NORMANDY HEIGHTS - PRD
STORM WATER DETENTION VAULT
WASHINGTON
CITY OF PUYALLUP
PRRWF20260365

STRUCTURAL NOTES & TYPICAL DETAILS
SHEET:
S1 OF 4
S-26-009

VAULT LID & FOUNDATION PLANS & DETAILS

WALL SECTIONS & DETAILS

LID REINF @ 12"ø VENT

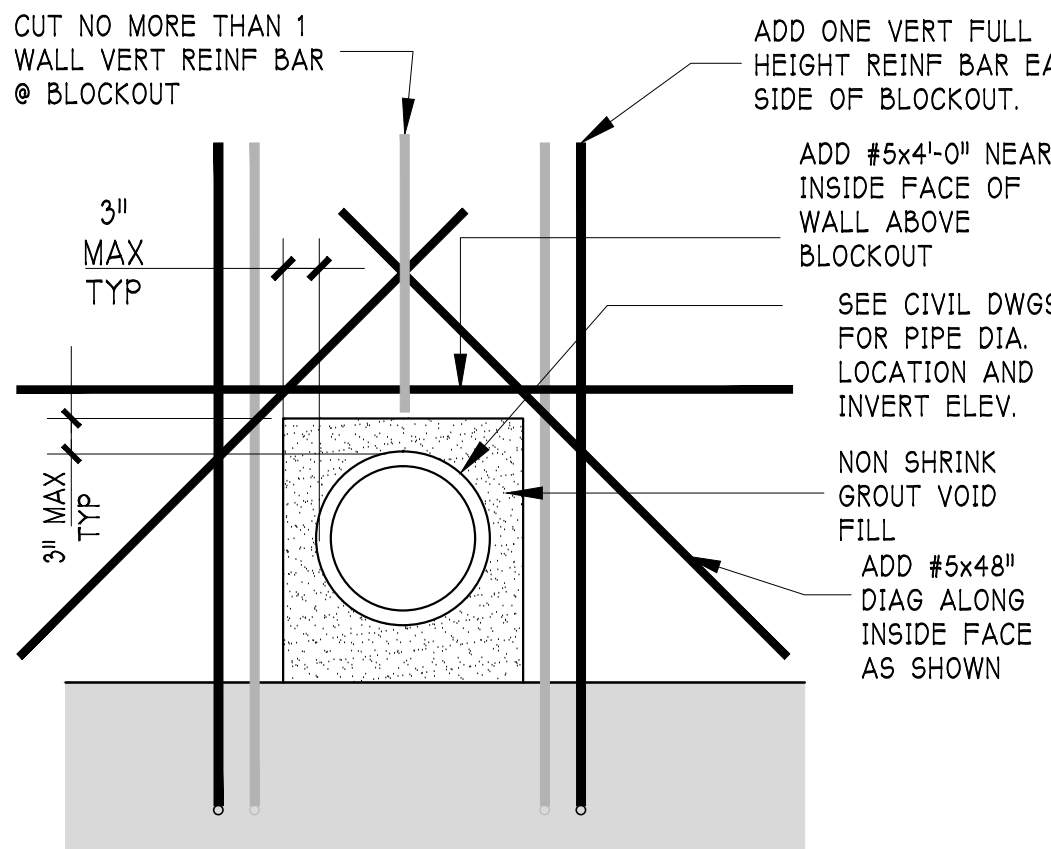
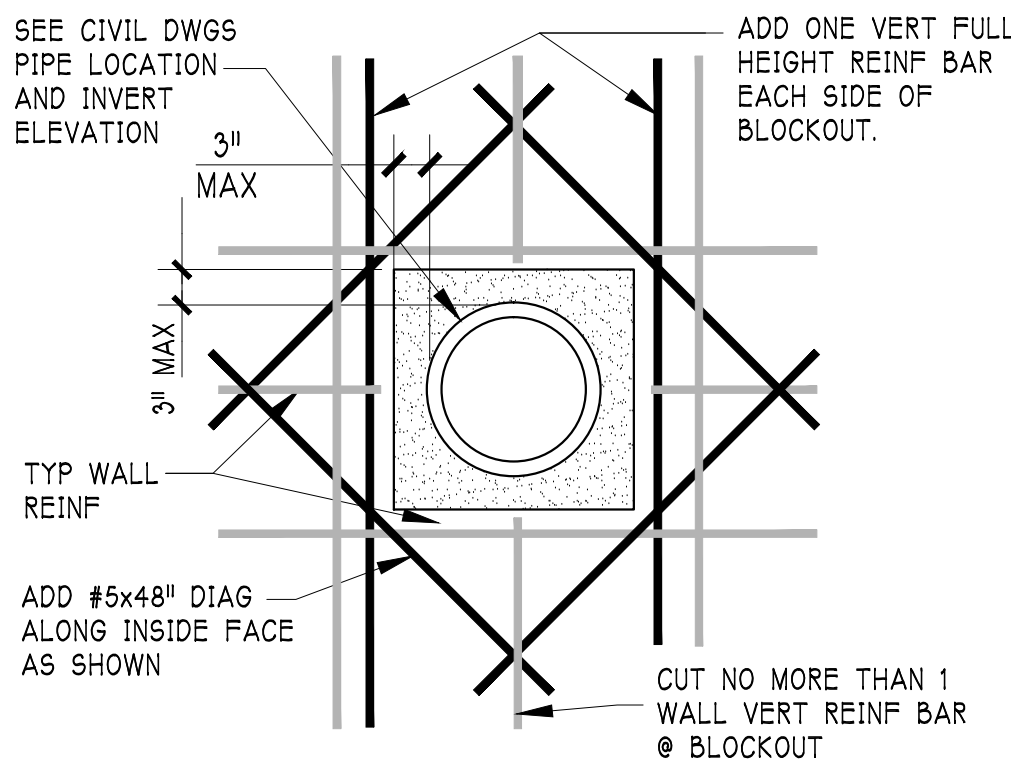
Detail 2/S1 is for reinf placement in the lid around a 12 inch opening. Provide detail for slab reinf placement or specify that this detail illustrates both.

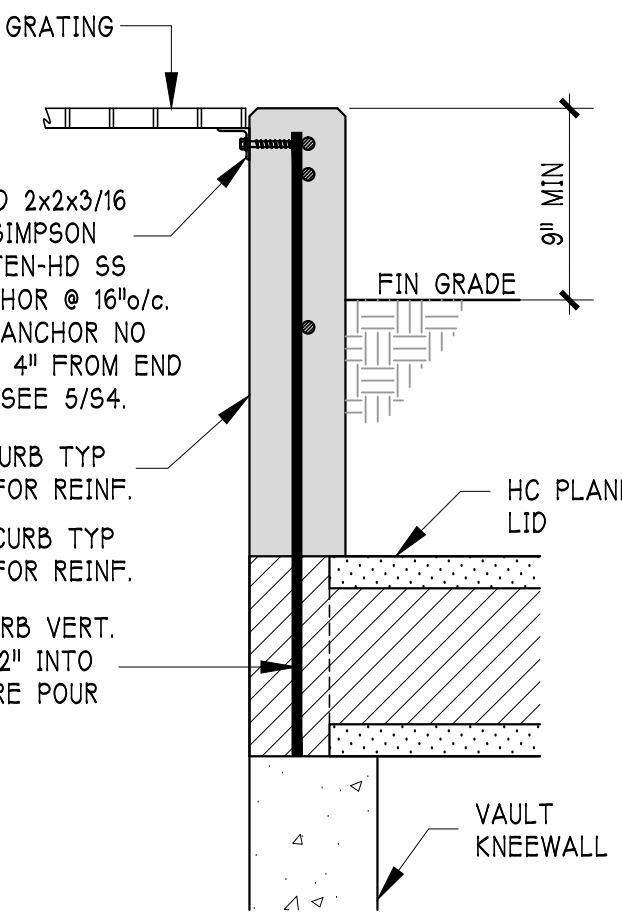
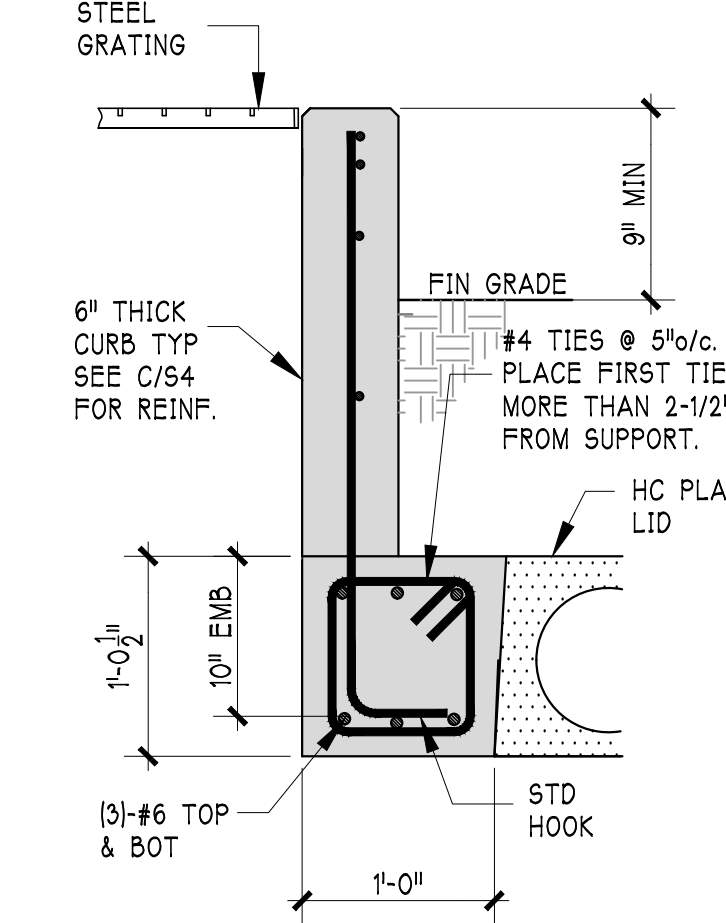
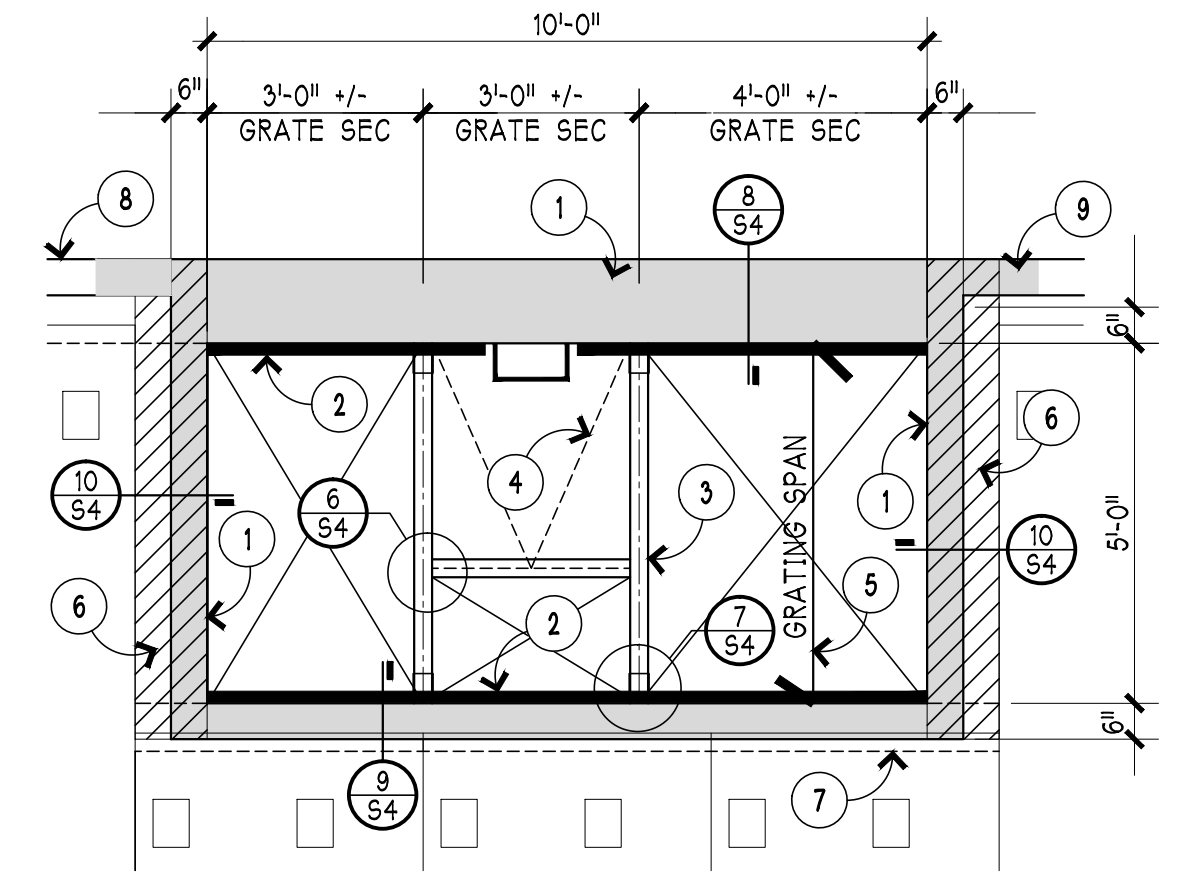
Call out all 3 details for reinf for 6 inch thick curb.
